**ADDENDUM NO. 2**

**For: Elementary School # 38  
522 Brookewater Boulevard  
Rosenberg, TX 77471  
for  
LAMAR CISD  
3911 Avenue I  
Rosenberg, TX 77471**

**ADDENDUM DATE: January 10, 2025**

**PROJECT NO: 24-028**

100% CONSTRUCTION DOCUMENTS  
**P2.01C**  
PLUMBING  
UNDERFLOOR PLAN -  
AREA C

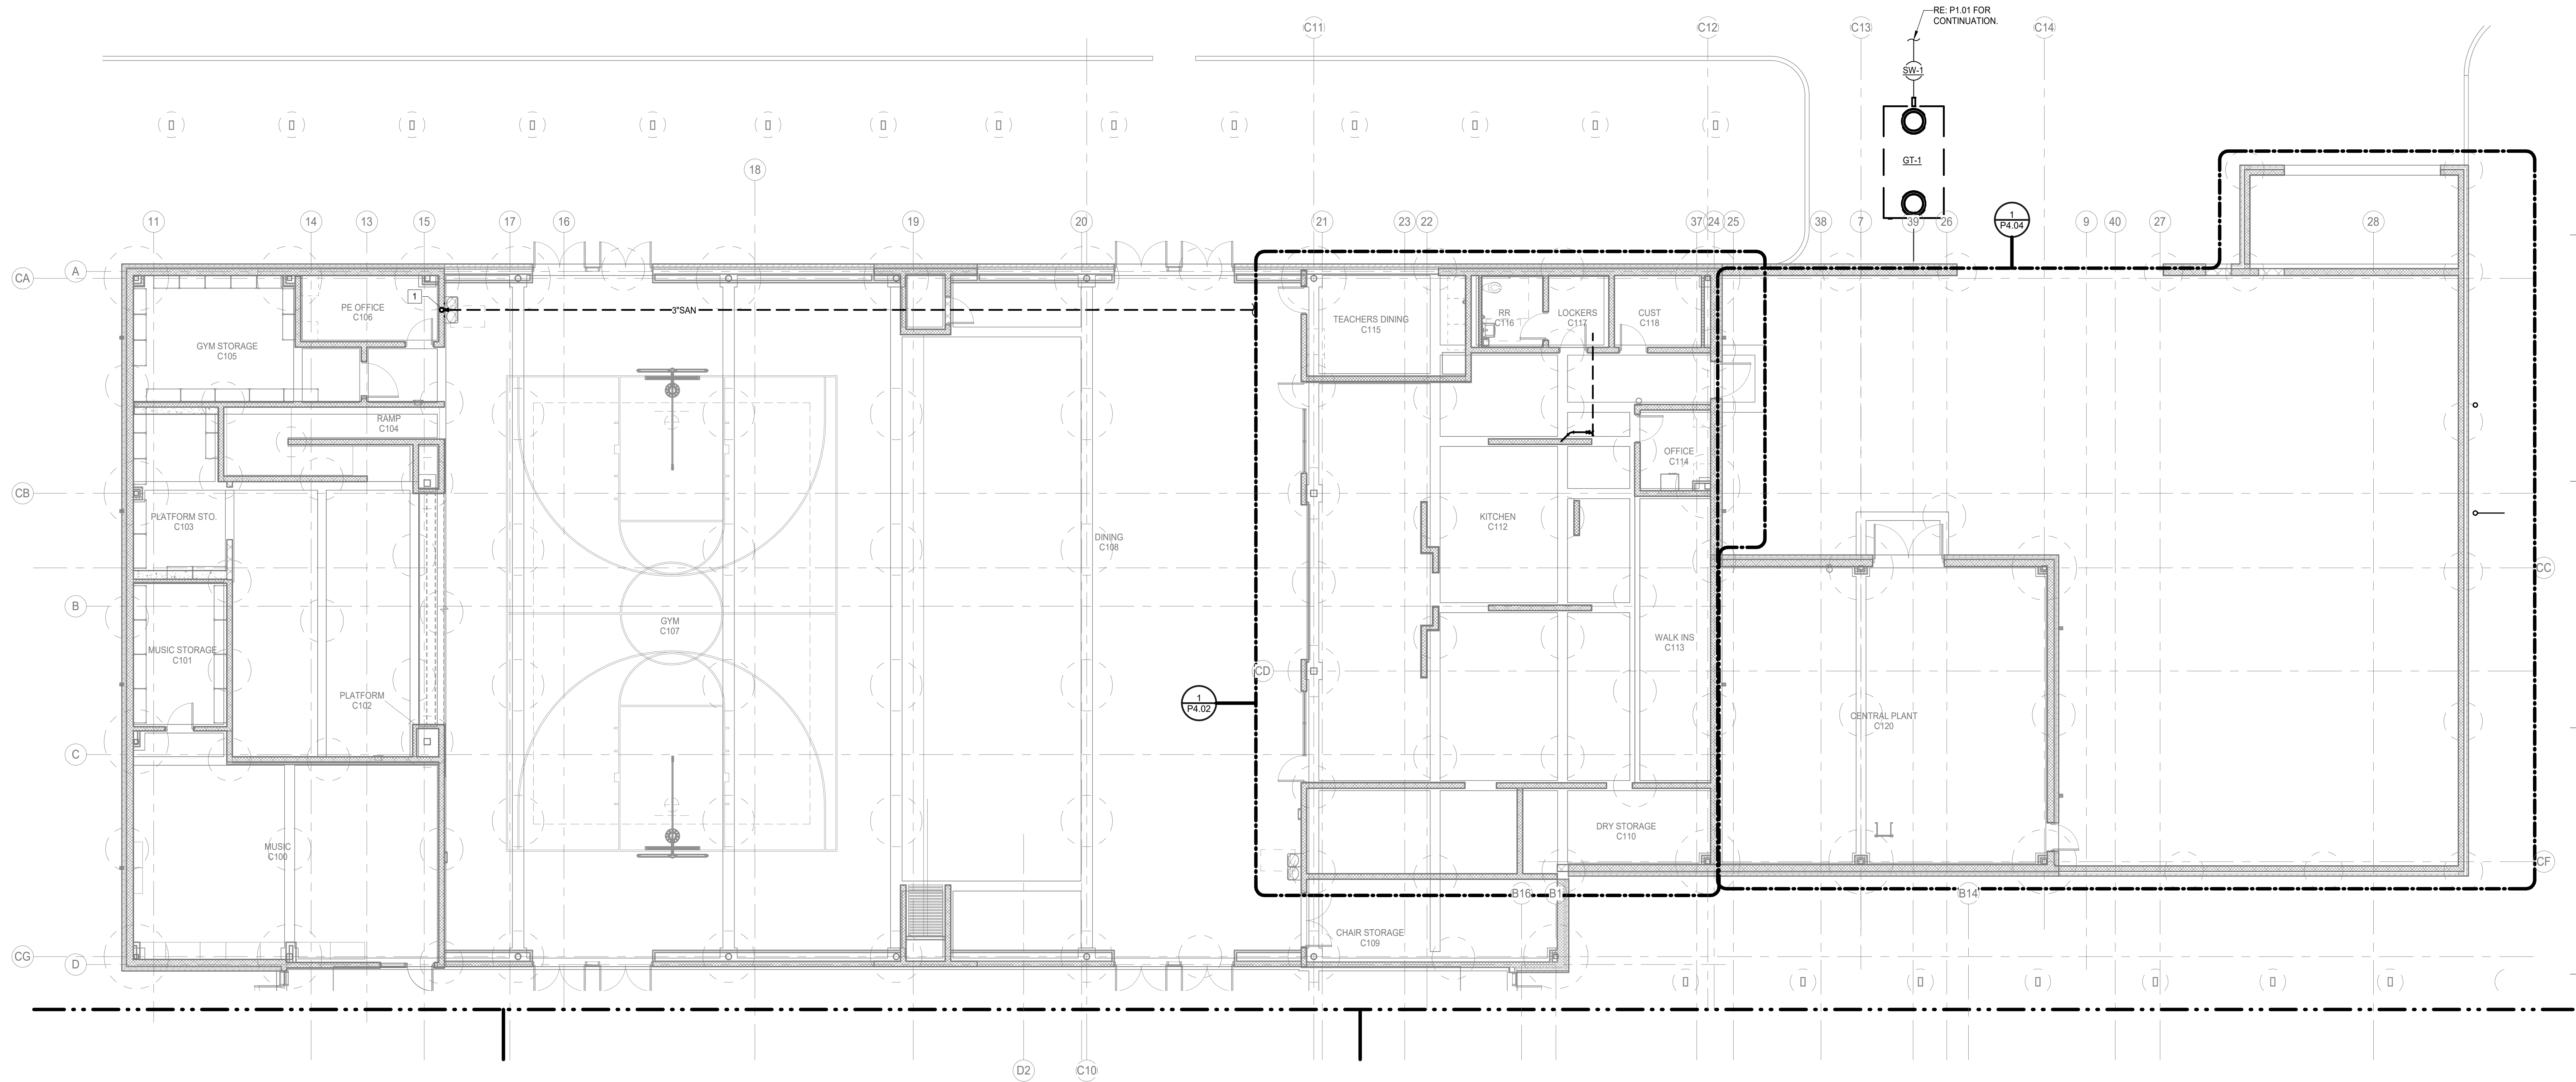
D2-52	P2.01C	Add pipe void system general note.
D2-53	P2.01D	Add pipe void system general note.
D2-54	P2.01E	Add pipe void system general note.
D2-55	P2.01F	Adjust sanitary piping and add pipe void system general note.
D2-56	P3.01A	Add TP-1 & TP-3 to serve floor drains/sinks.
D2-57	P3.01B	Revise wall hydrant location.
D2-58	P3.01D	Revise sanitary piping and add TP-1 to serve floor drains/sinks.
D2-59	P3.01E	Add TP-1 to serve floor drains/sinks.
D2-60	P3.01F	Add TP-1 to serve floor drains/sinks.
D2-61	P3.02	Add DN-1 from high roof to lower roof.
D2-62	P4.01	Add TP-1 to serve floor drains/sinks.
D2-63	P4.03	Add new sheet to set.
D2-64	P4.04	Revise gas piping and water piping.
D2-65	P4.06	Hide mechanical equipment.
D2-66	P5.00	Revise plumbing details.
D2-68	P5.02	Add roof drain insulation detail.
D2-69	P6.00	Revise circulation pump schedule.
D2-70	P6.01	Revise plumbing fixture schedule.
D2-72	T2.01	Remove classroom entrance conduits.
